Site Design Comments (including Complete Streets)

2001 RICHMOND STREET
CIVIC DESIGN REVIEW
09.16.2024

**MIXED USE BUILDING
ELEVATIONS**

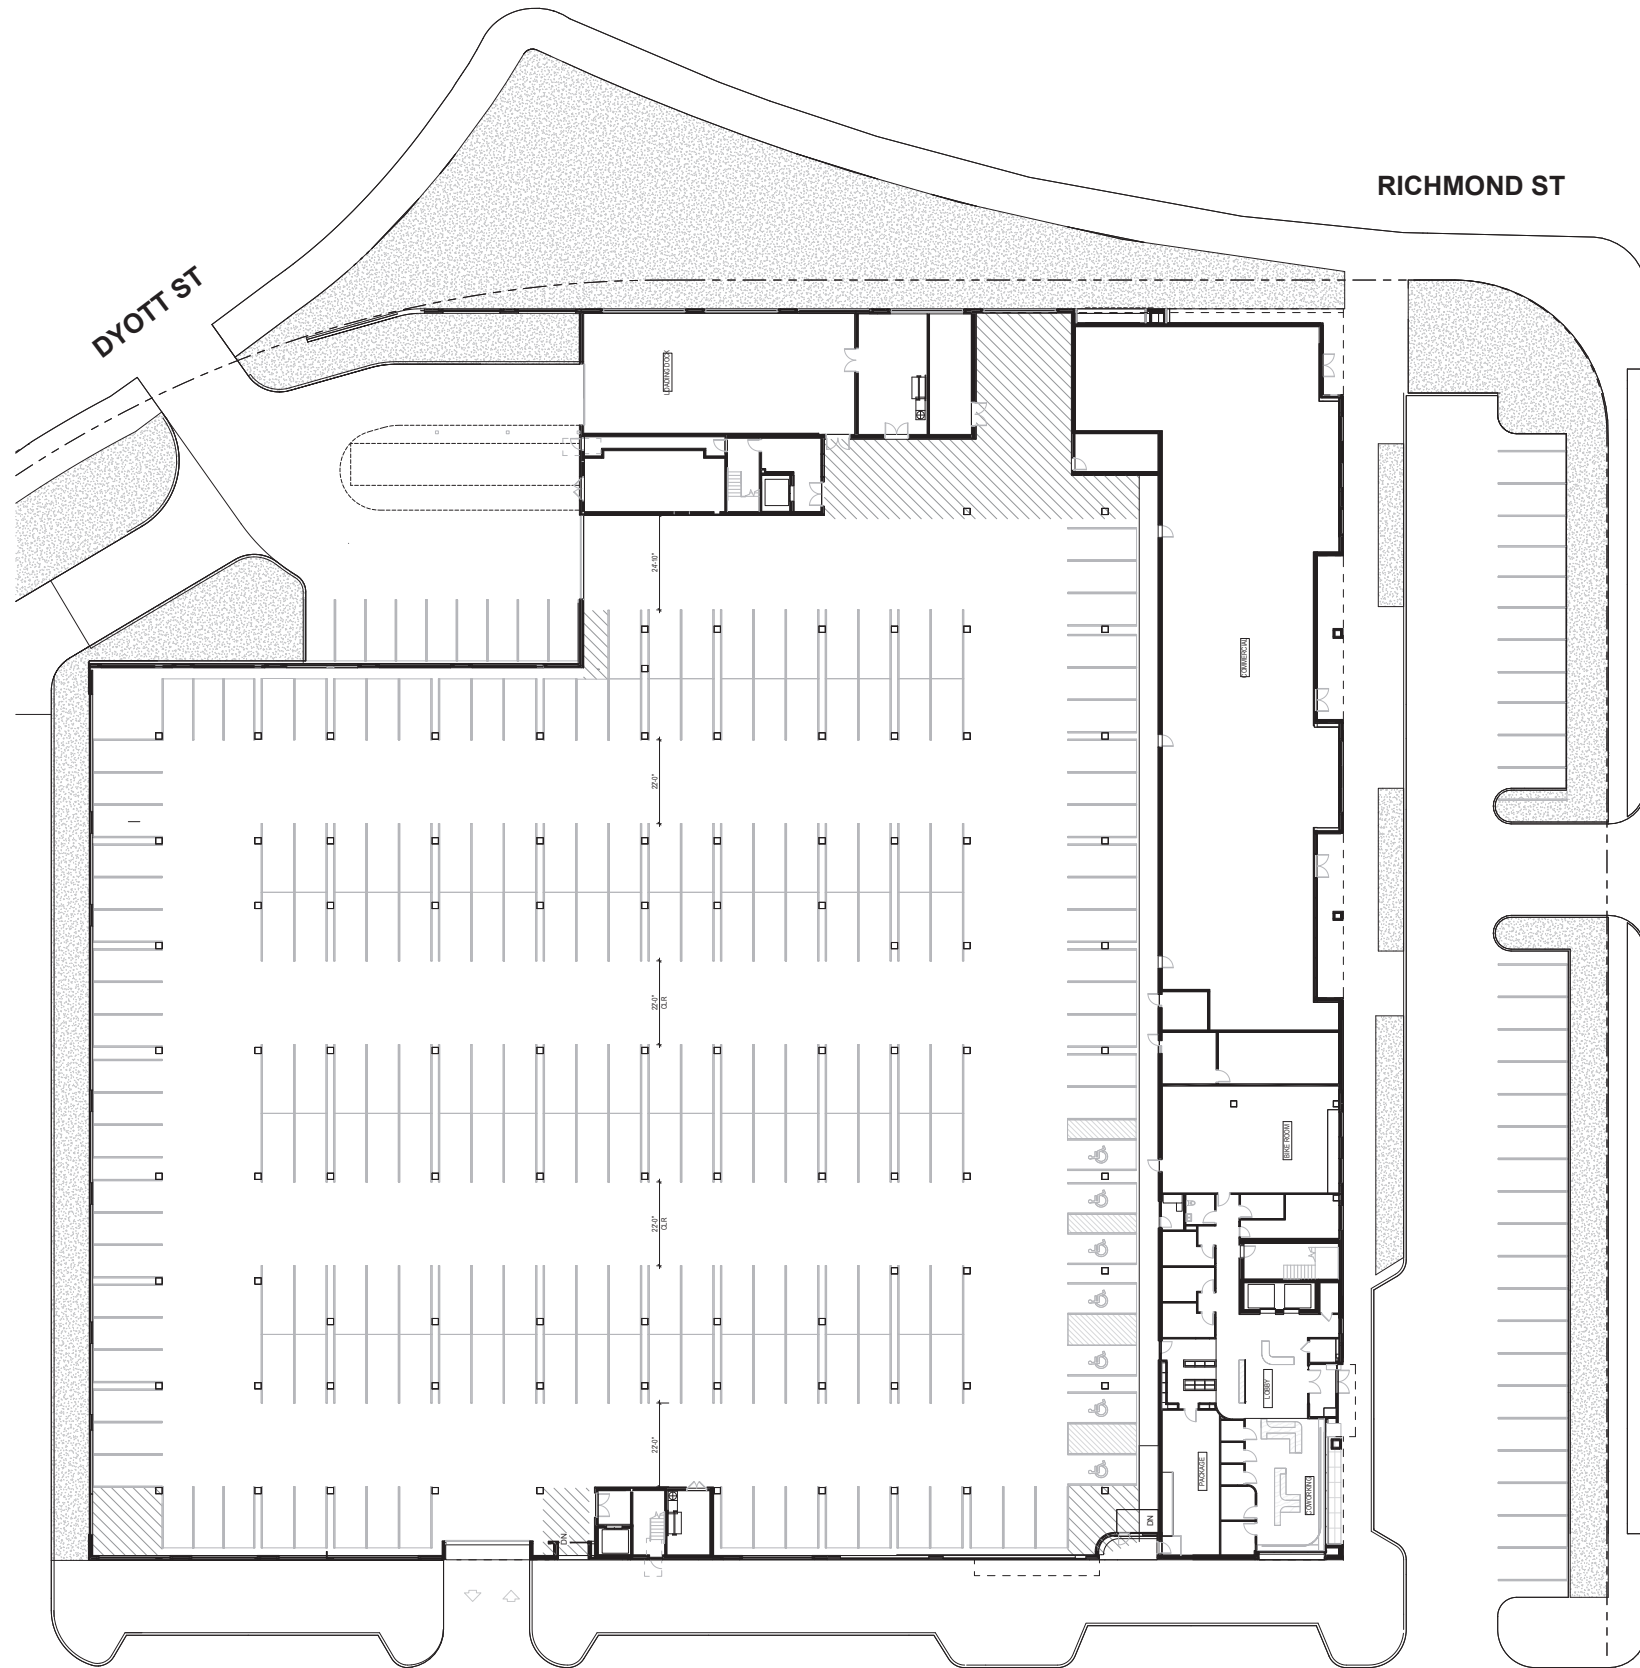
5 Staff recommends limiting the use of dark colored standing seam and corrugated metal panels on public-facing facades.

Noted and we have worked to maximize the presence of masonry at the ground and on the most prominent and visible facades. Final color selection will take this comment into account.
